SUBJECT: Request for Approval of Page Change 2008-001 to the WIPP Safety Basis Documents

**Safety Evaluation Report
of the Waste Isolation Pilot Plant
Contact Handled (CH) Waste Documented Safety Analysis (Revision 10),
Contact Handled (CH) Technical Safety Requirements (Revision 10),
Remote Handled (RH) Waste Documented Safety Analysis (Revision 0), and
Remote Handled (RH) Technical Safety Requirements (Revision 0)**

Page Change 2008-001

Justification for RH and CH TSR/DSA Page Changes 2008-001 to Add Panel 5 to the Disposal Ventilation Circuit

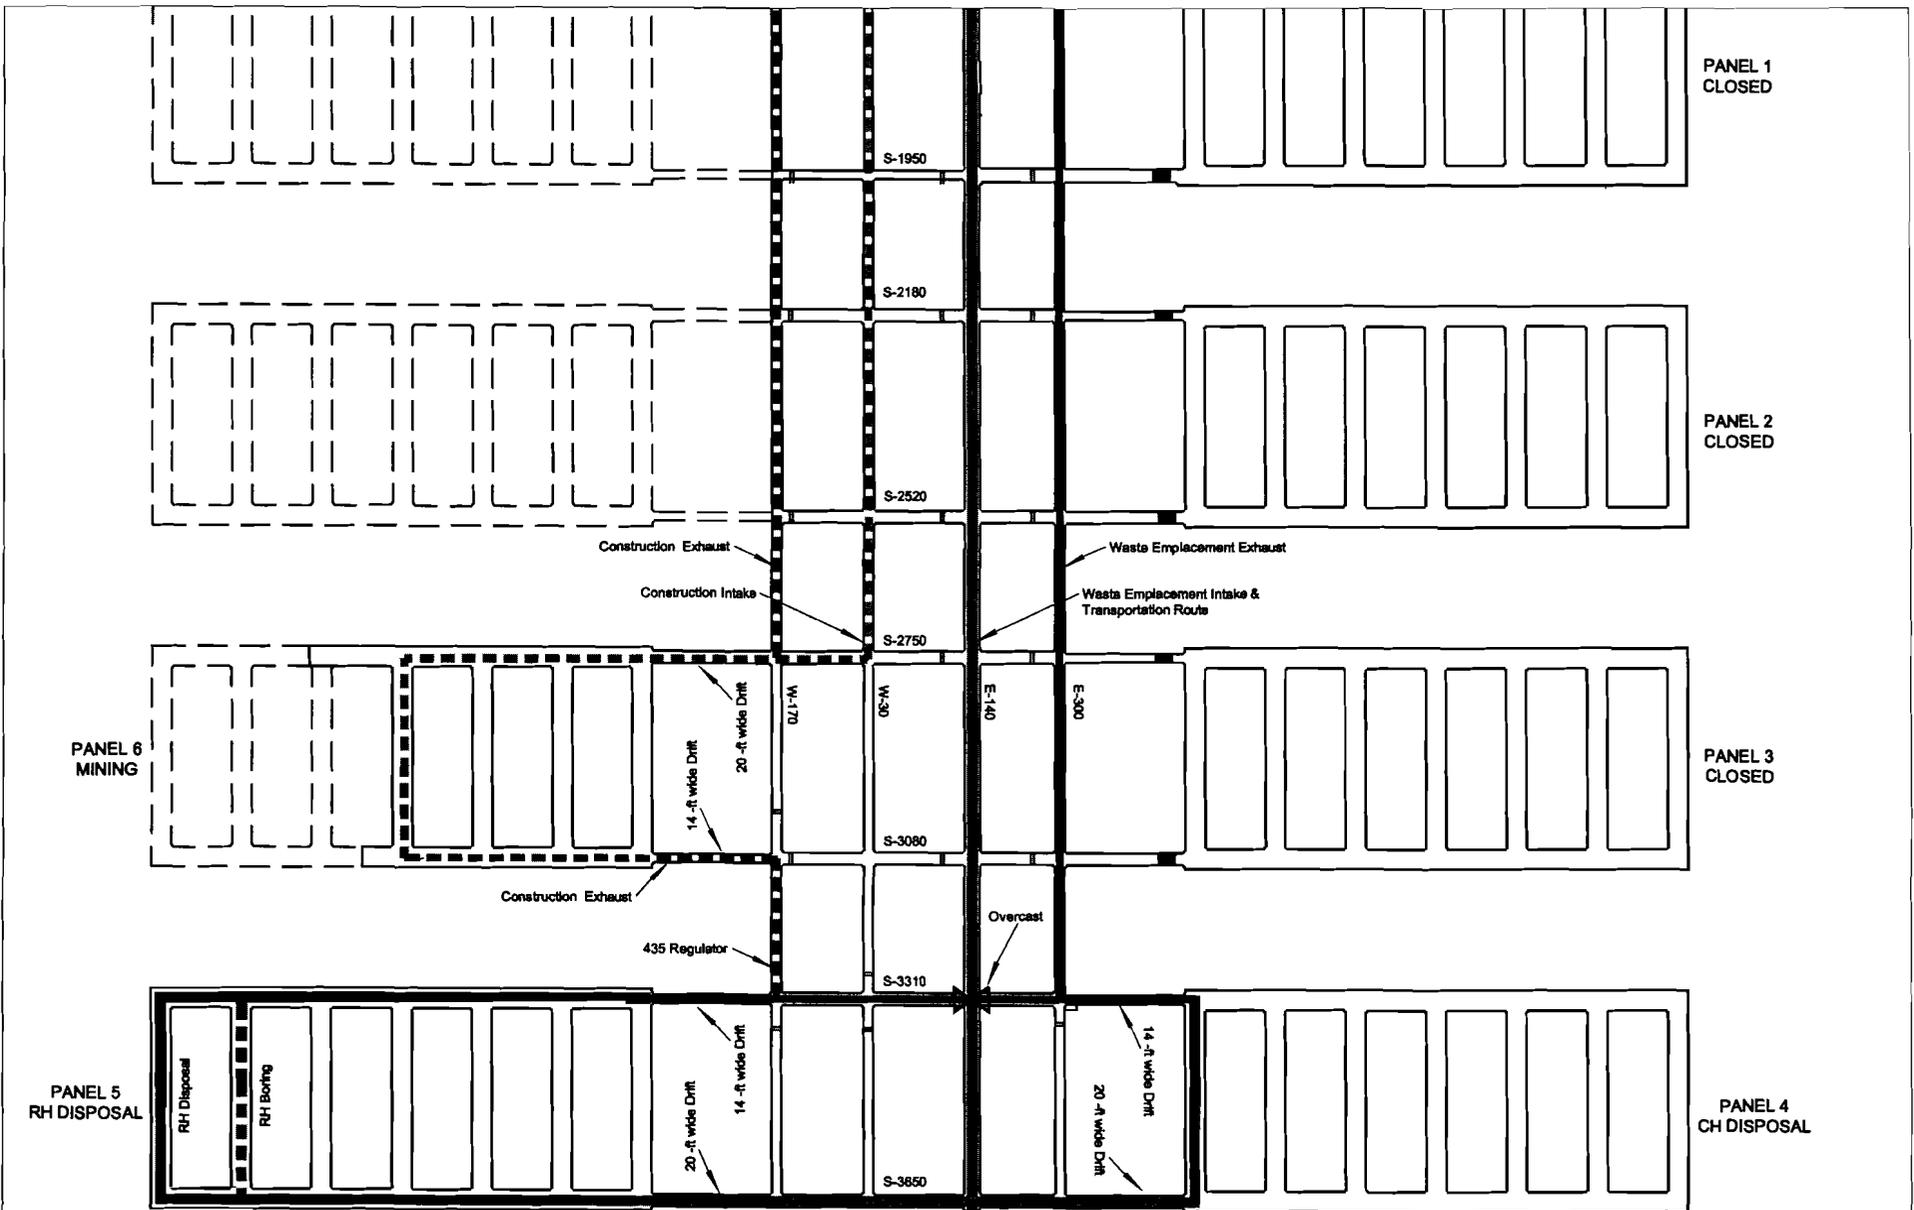
These TSR requirements were appropriate during construction of panels 3 and 4 as construction activities could occur near the supply overcast for panels 2 and 3. Waste traversed through the overcast to enter the active disposal panel. Further, during construction of panel 5 construction activities near the overcast at E-140/S-3310 had the potential to impact waste being transported through the overcast enroute to panel 4.

For panels 5 through 8 this part of the TSR is no longer required. Only two overcasts are proposed to facilitate mining panels 6 through 8, the one already installed at E-140/S3310 and one yet to be installed at S2180 which are used to divert exhaust air. The proposed ventilation changes to accommodate mining new panels 5 through 8 and moving completed panels into the disposal ventilation circuit are shown in Figures 1 through 6.

Figure 1

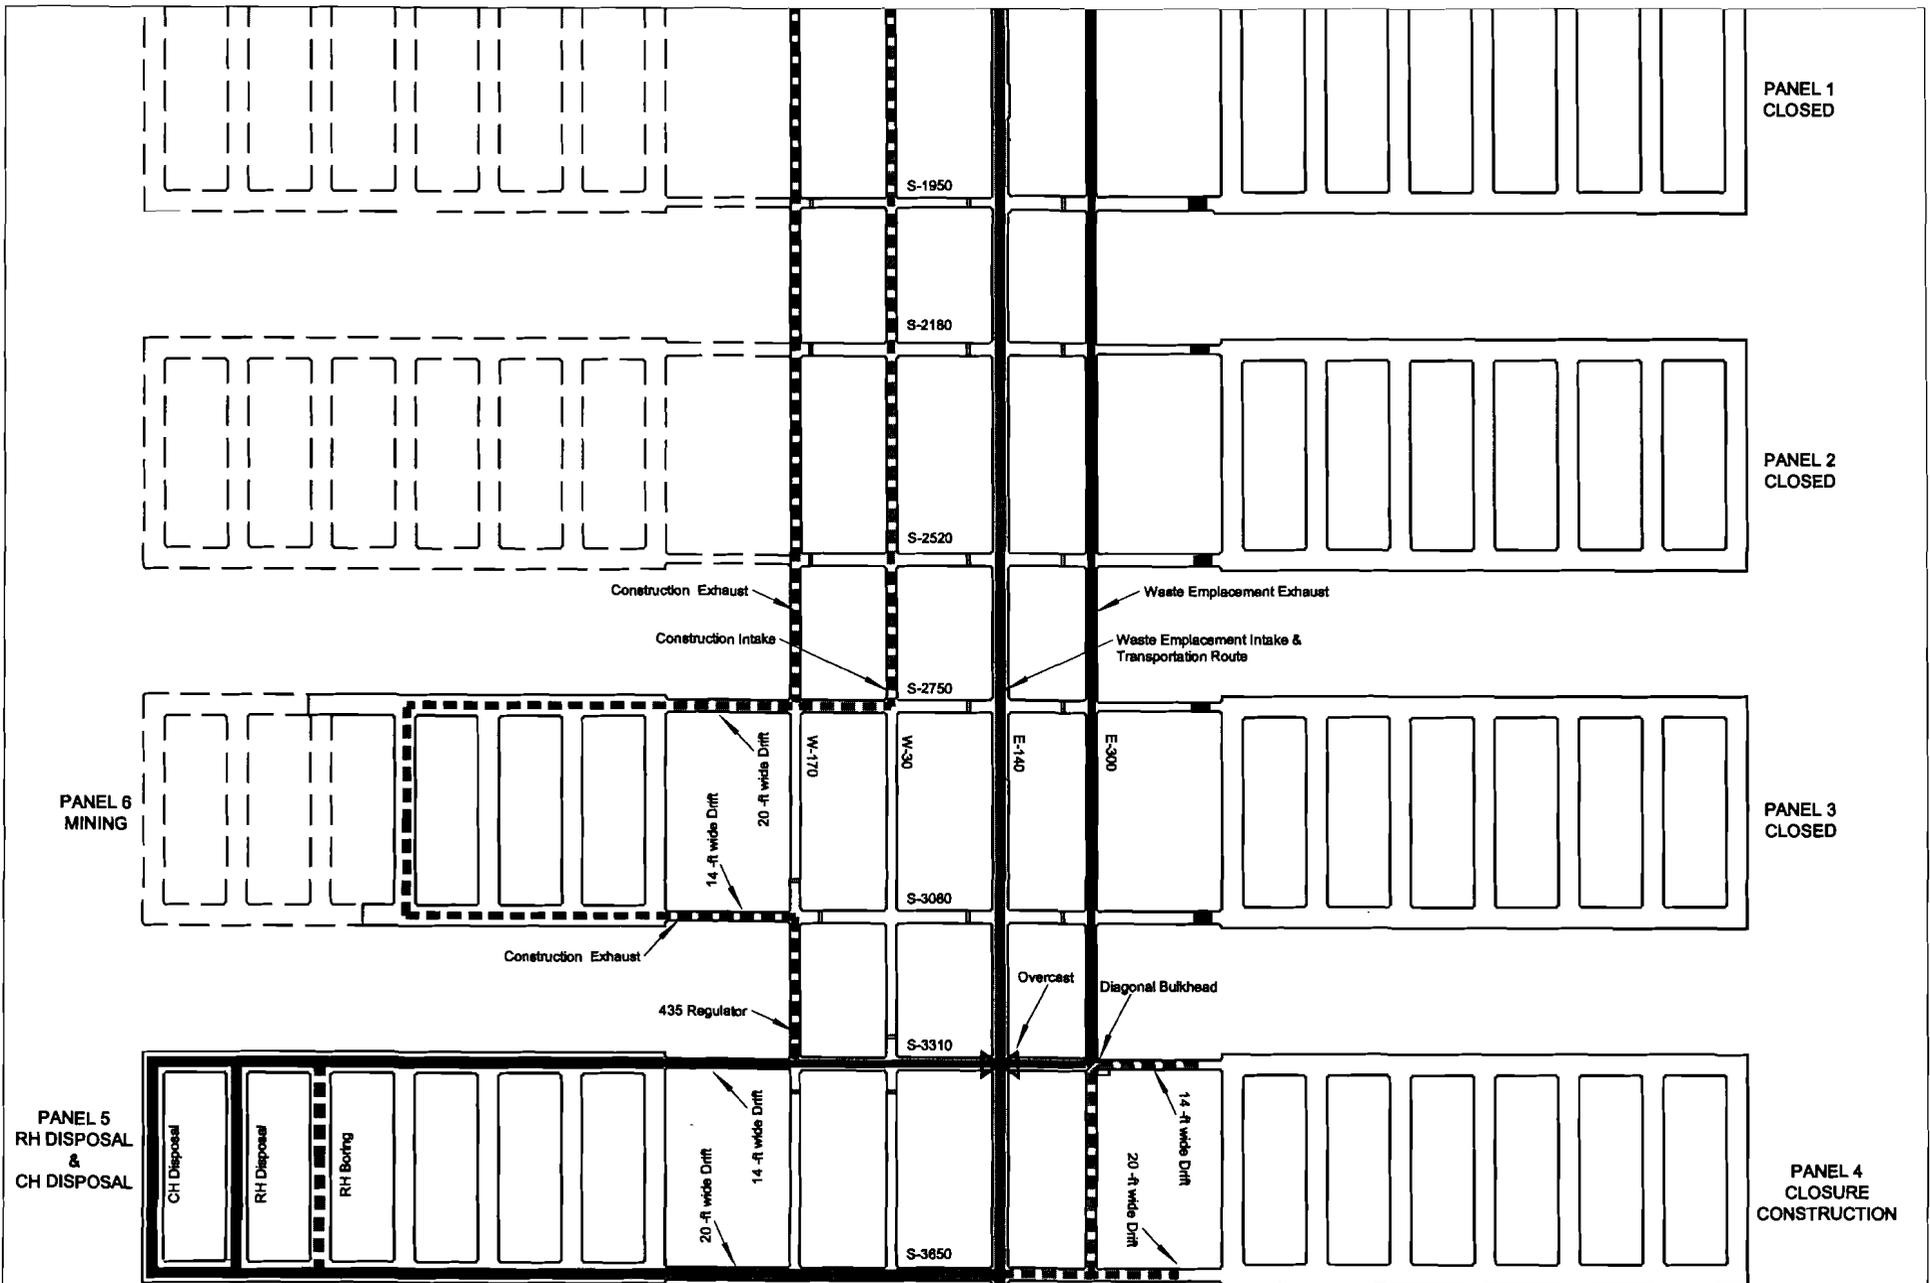
- 1) For Panel 5, make S-3650 the intake and waste transportation route.
- 2) For Panel 5 make S-3310 the exhaust drift and install an overcast in S-3310 at E-140 to allow the exhaust and intakes to cross.

This would make S-3650 from W-170 to Room 1 Panel 5 20 feet wide and S-3310 would be 14 feet wide.

Figure 2

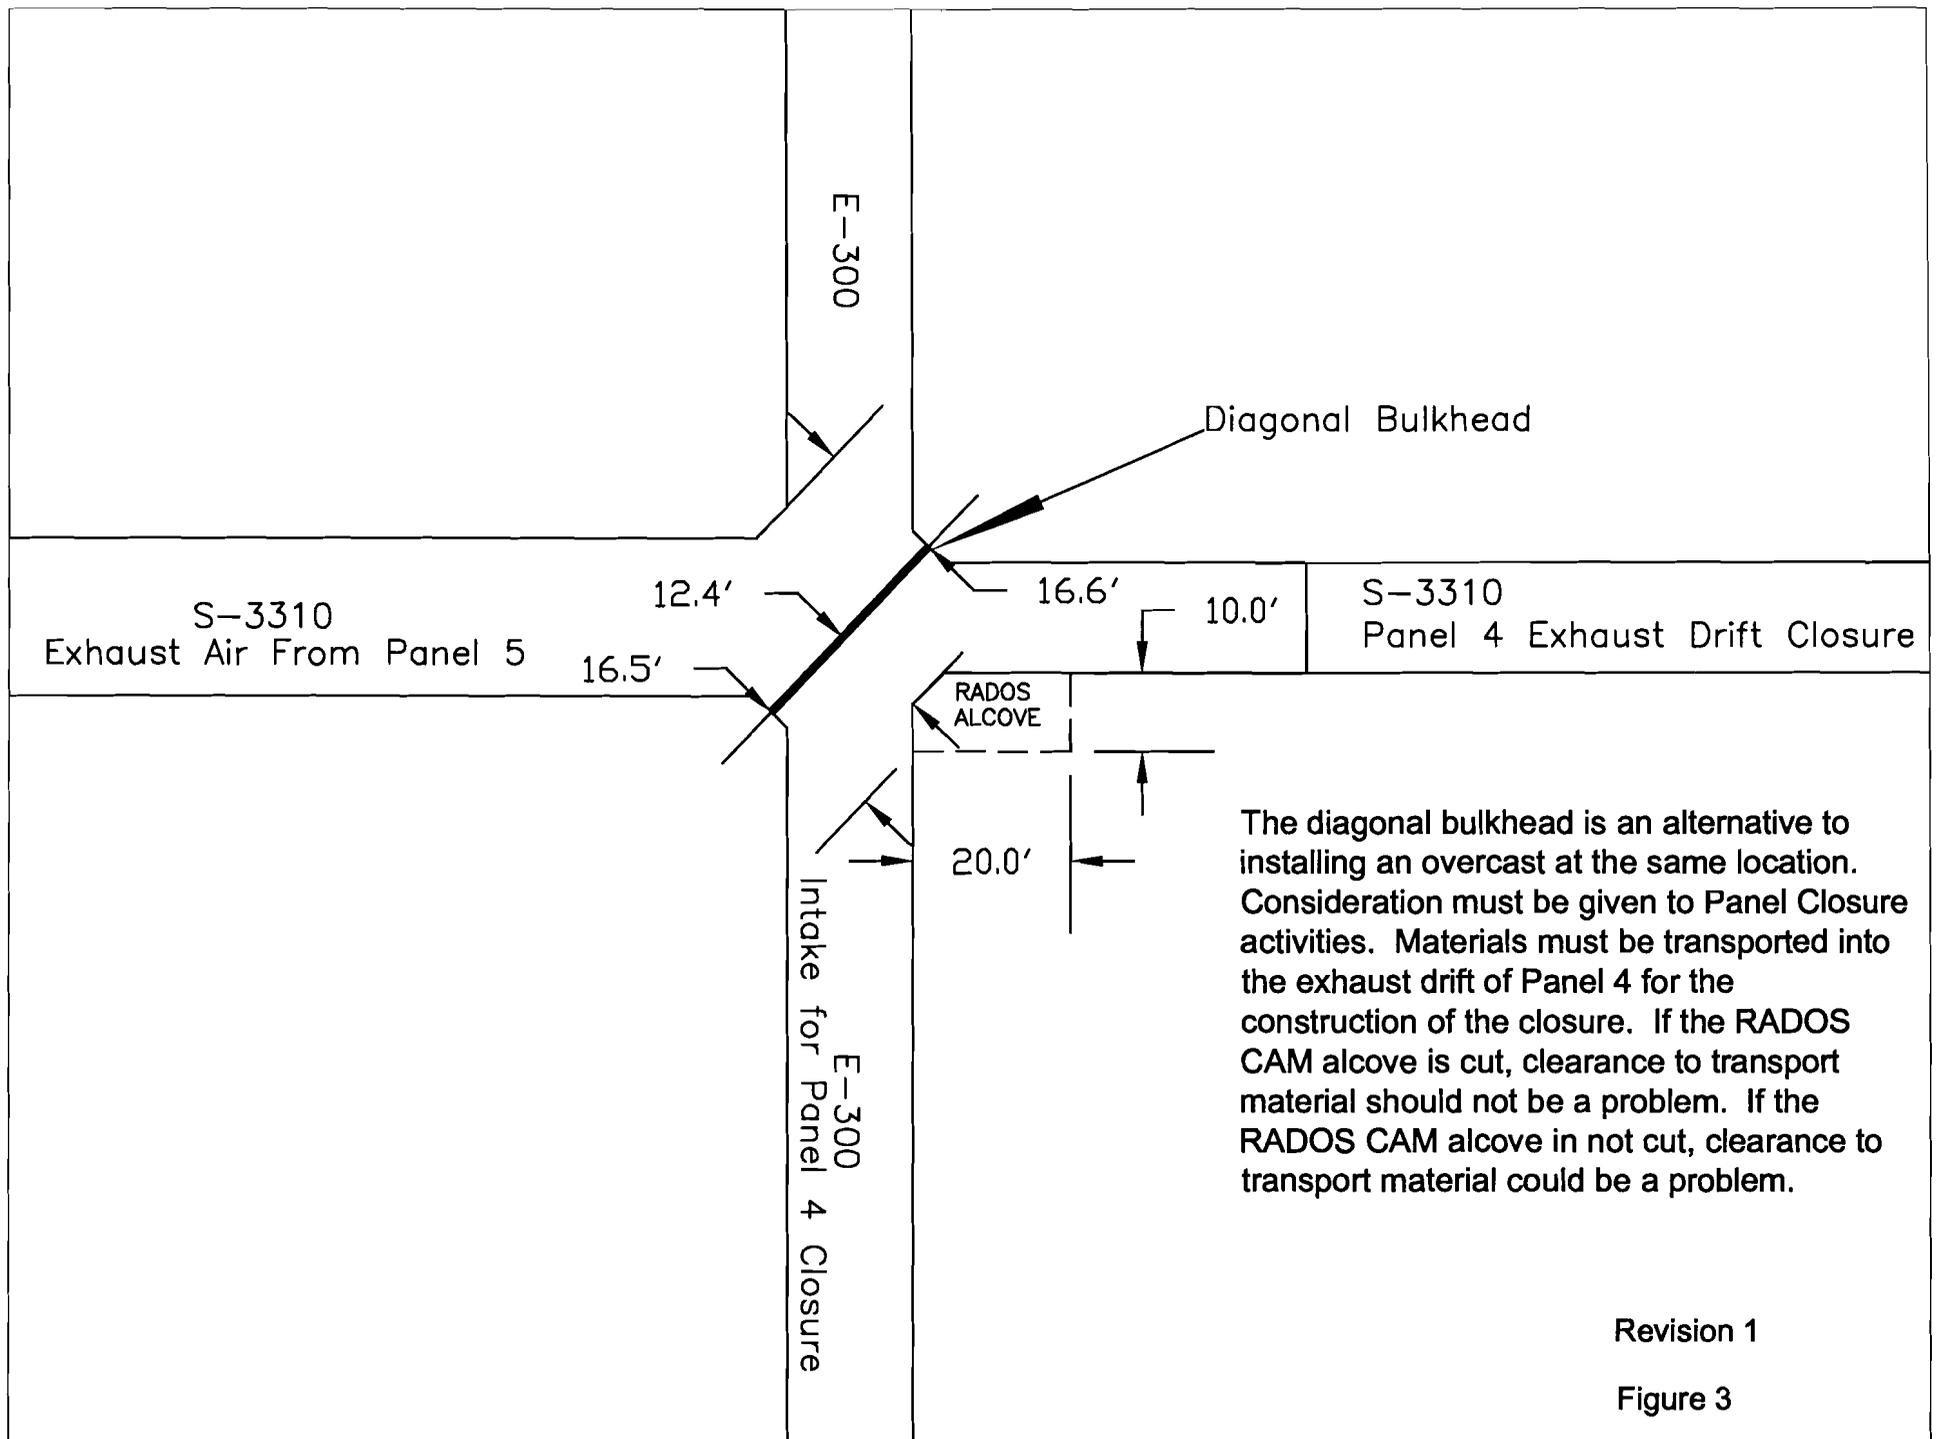
Figures 2 and 3 show that when panel 5 is added to the disposal ventilation circuit, there is no longer construction activities near the overcast at E-140/S-3310 that could impact waste traversing through the overcast. Figure 5 shows that when panel 6 is added to the disposal circuit, the panel supply will be separated from construction by bulkheads in W-30 and W170 just north of S-2750. Similarly, panels 7 and 8 will be added to the disposal circuit when mining is complete in much the same way as panels 5 and 6 will be added.

When it is time for construction of the Panel 4 Closure, a diagonal bulkhead must be installed in S-3310 at E-300. This bulkhead will allow construction of the exhaust closure in intake air.

Figure 5

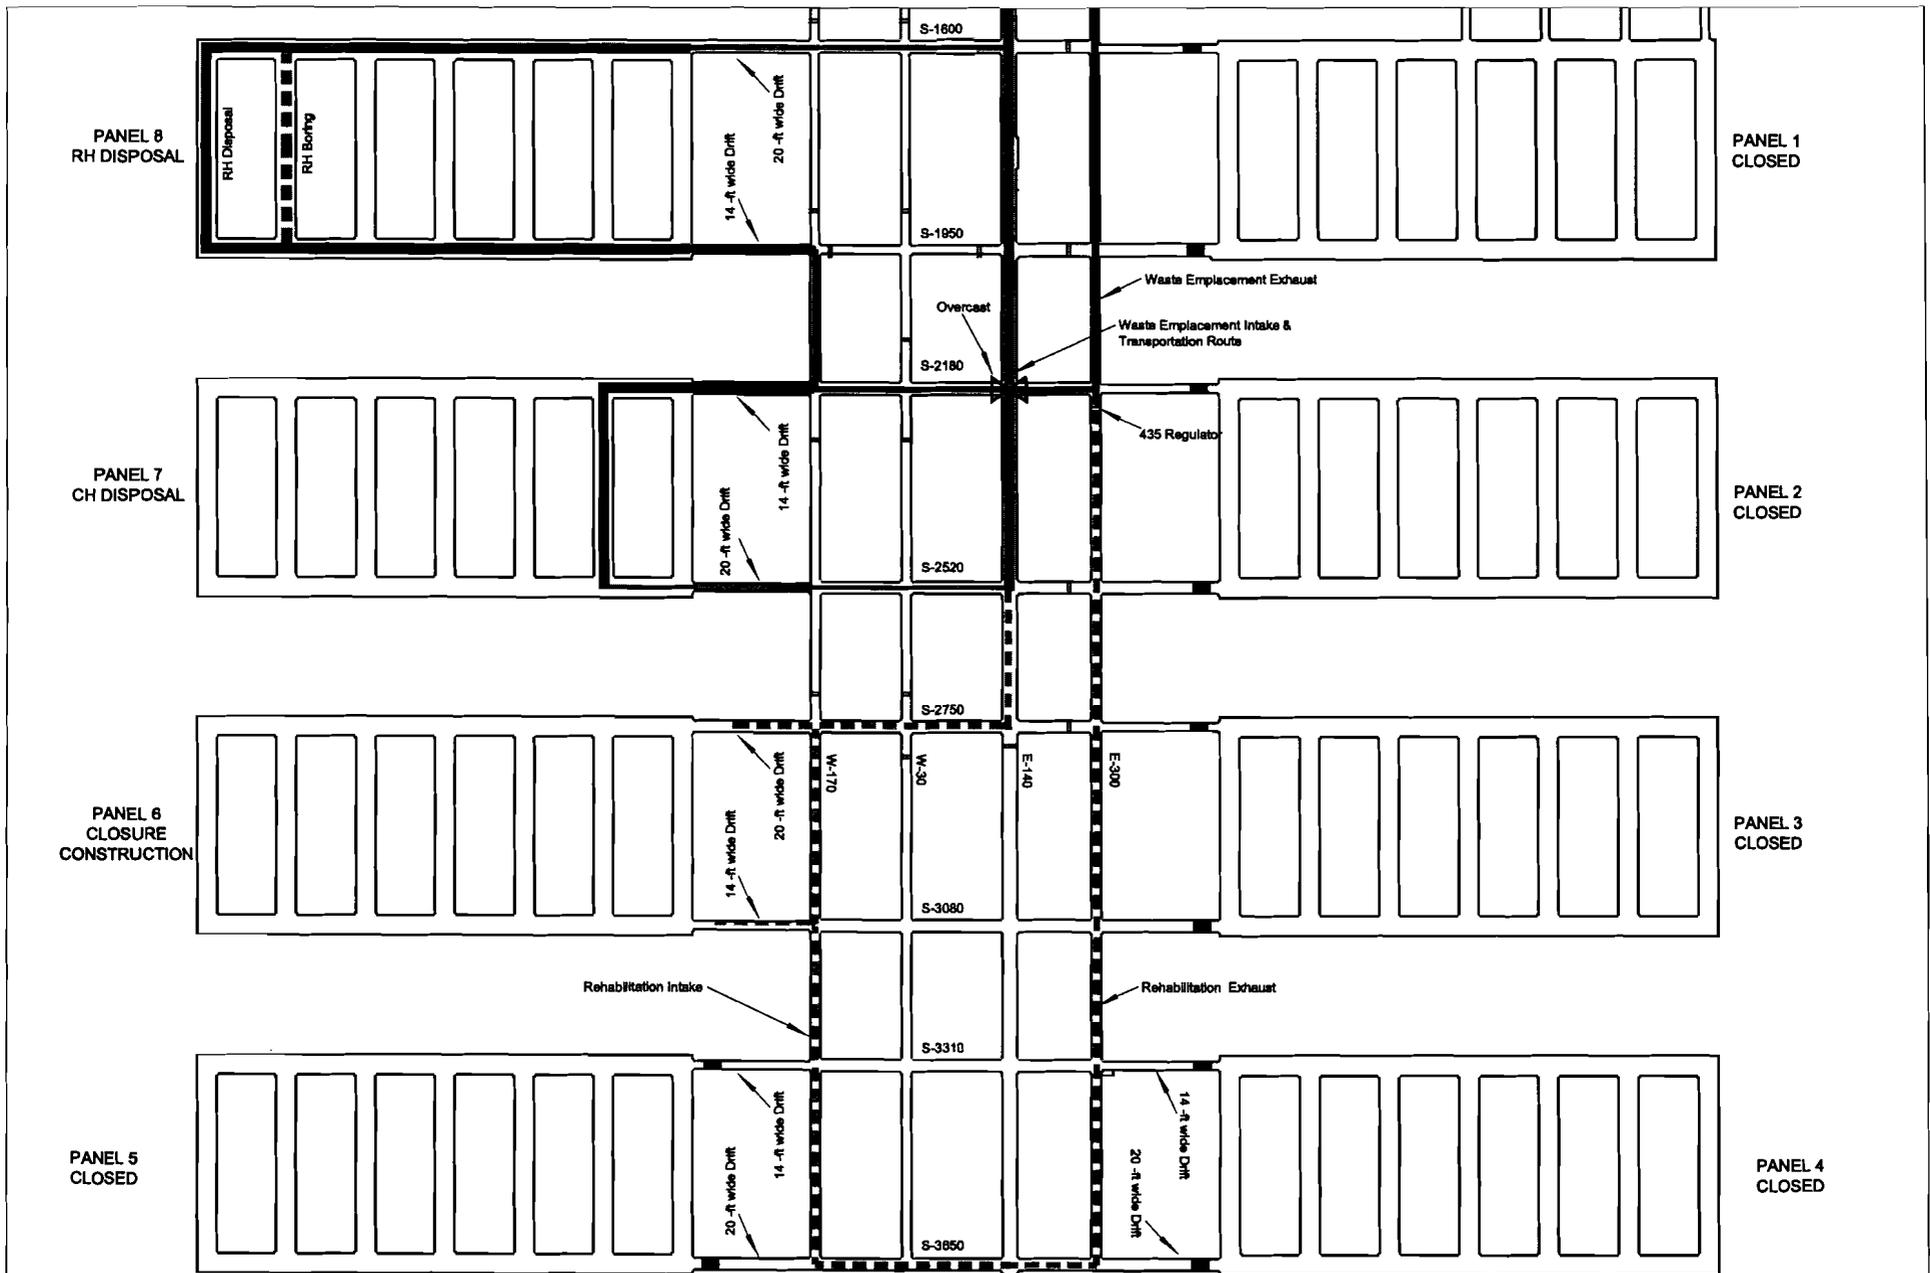
For waste disposal in Panel 7 the intake will be S-2520 and exhaust air will travel through S-2180, over an overcast at E-140 and into E-300. The diagonal bulkhead in S-3310 at E-300 will be removed at completion of the Panel 4 Closure.
